Subject: Formal objection notice regarding alterations and additions at 2 Montague

Place, North Manly - DA2020/1129

Re: Objection Notice - Alterations and Additions to a dwelling house- 2 Montague Place, North Manly

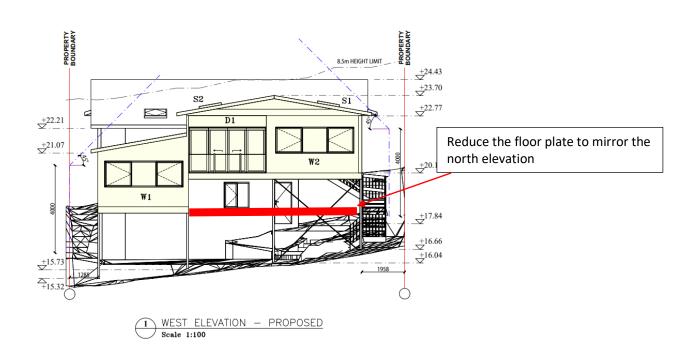
The proposal will aggravate overshadowing of the southern elevation of my client's dwelling and this is due to the inappropriate built form.

Based on the concept, there is to be adverse over shadowing of my client's floor plate (rear portion of the existing dwelling) will prevent natural light penetrating into the kitchen and is the main part of the dwelling that is used by Client's family.

The drawings submitted with the development proposal do not appear accurate and separate independent verification is necessary.

A reduction to the height of the building may assist address solar access concerns.

# Contention 3- Appearance of a 3-storey dwelling (D9)

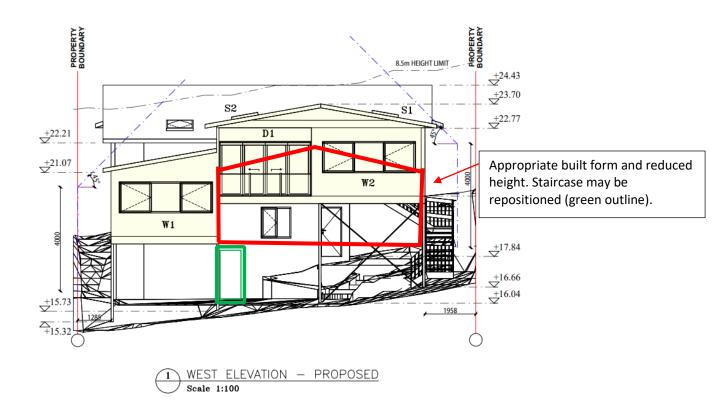
The rear appearance of the additions presents as a 3-storey dwelling built form and may allow the under croft to be converted as additional floor space.

Any under croft area in future should not be used as floor space or suitable conditions of consent are imposed to control this concern.

The building designer provides a stepped floor plate, and there is no reason why the complete floor plate cannot be dropped to reduce the bulk of the dwelling and this is shown in a heavy red line).

# **Contention 5- Privacy impacts (D8)**

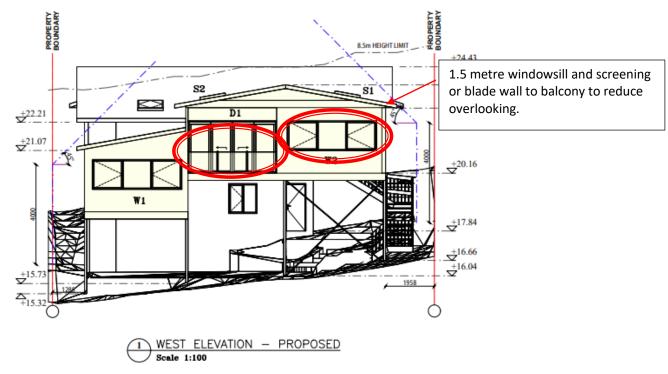
The proposed open staircase and doorway will overlook into my clients' rear private open space area.

There has been no attempt to reduce overlooking and we suggest privacy screens are adopted and 1.5 metres high windowsill.
